## DS-K1T341A Series MinMoe Terminal

### Release Notes (2022-02-09)

<b>Device Model:</b> DS-K1T341AM DS-K1T341AMF	Firmware Version	ARM: ACS_641_AI3_EN_STD_V3.2.30_build211229 ACS_641_AI3_EN_NEU_V3.2.30_build211229
	SDK	Latest version
<b>Naming Rule:</b> M for M1 card, F for fingerprint	iVMS-4200 Client Version	Latest version baseline

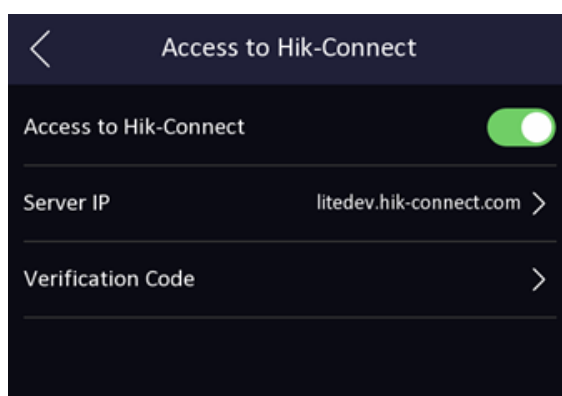
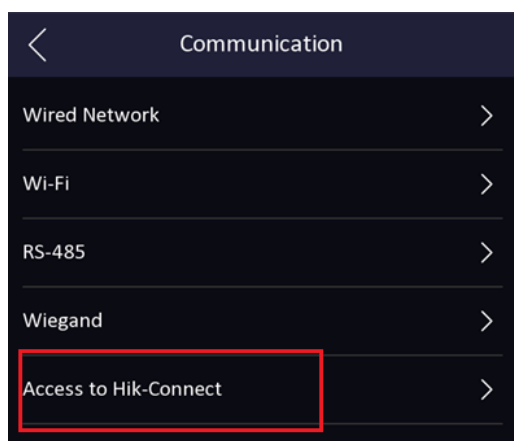
1. Add Hik-Connect menu in device UI Menu→Comm. The function is disabled in default.

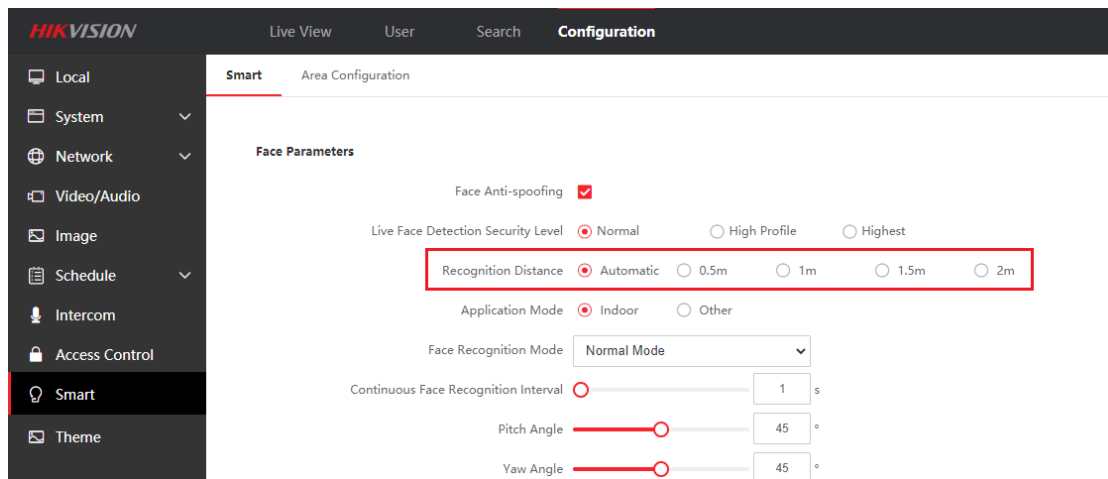
1. Optimize the wake-up distance of the device screen through the face, and the wake-up distance is consistent with the recognition distance
